REGULATORY OBSERVATION	
REGULATOR TO COMPLETE	
RO unique no.:	RO-ABWR-0073
Date sent:	15th August 2016
Acknowledgement required by:	6th September 2016
Agreement of Resolution Plan Required by:	<i>To be determined by Hitachi-GE Resolution Plan</i>
Resolution of Regulatory Observation required by:	<i>To be determined by Hitachi-GE Resolution Plan</i>
TRIM Ref.:	2016/323037
Related RQ / RO No. and TRIM Ref. (if any):	RO-ABWR-0016 (Trim Ref. 2014/253045); ; RO-ABWR-0037 (Trim Ref. 2015/20684); RO-ABWR-0044 (Trim Ref. 2015/59719); RO-ABWR-0054 (Trim Ref. 2015/181094); RO-ABWR-0064 (Trim Ref. 2015/390811); RQ-ABWR-0083 (Trim Ref. 2014/118093); RQ-ABWR-0781 (Trim Ref. 2016/88145); RQ-ABWR-0782 (Trim Ref. 2016/88165); RQ-ABWR-0783 (Trim Ref. 2016/88184); RQ-ABWR-0784 (Trim Ref. 2016/88221); RQ-ABWR-0785 (Trim Ref. 2016/88247); RQ-ABWR-0786 (Trim Ref. 2016/88273); RQ-ABWR-0787 (Trim Ref. 2016/88303).
Observation title:	Robust demonstration that the design of the UK ABWR off-gas system reduces risks SFAIRP

Figure 1: Schematic of the current design of the UK ABWR off-gas system [1]

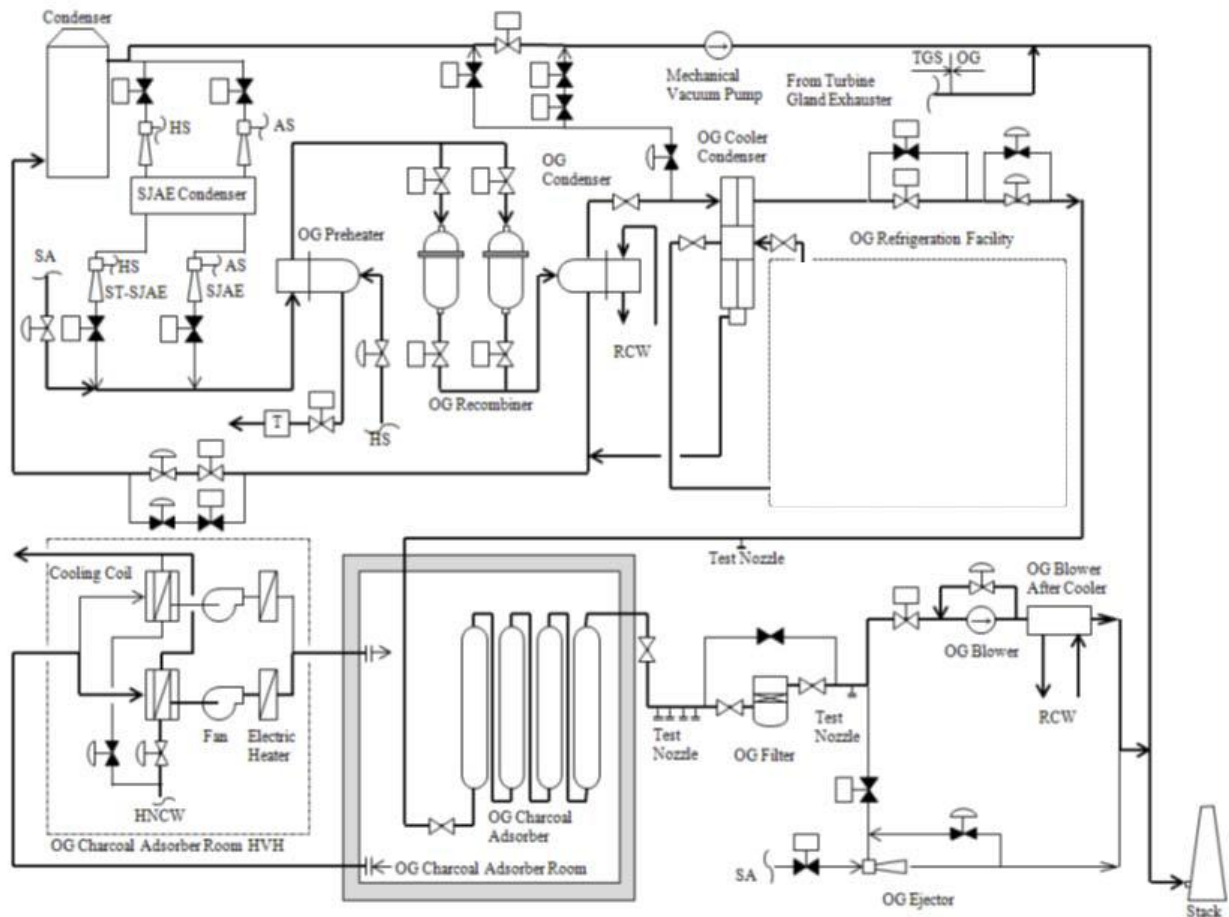
Despite this, gaps still remain and ONR has identified some specific reservations (addressed by the Regulatory Observation Actions attached to this RO) with the approach being taken by Hitachi-GE to justify the design of the off-gas system, overall, is ALARP. For example, when considering the design of BWR (and similar systems for other reactor technologies) off-gas systems, there are several different options which could be implemented. For example, with specific reference to **Figure 1** above:

- Some BWRs have a 'guard bed' installed upstream of the charcoal adsorbers to protect the beds from the deleterious effects of moisture ingress;
- Charcoal adsorber beds could be arranged in series, in parallel and/or be segregated;
- The operating temperature of the charcoal adsorber beds (therefore design of the system) has important implications for the performance of the off-gas system;
- Different design and operational considerations for off-gas systems may provide different hold-up (decay) times for krypton and xenon radioisotopes.

So far, Hitachi-GE has not provided responses which demonstrate adequate consideration has been given to these, and other factors, to demonstrate the overall design of the UK ABWR off-gas system is ALARP.
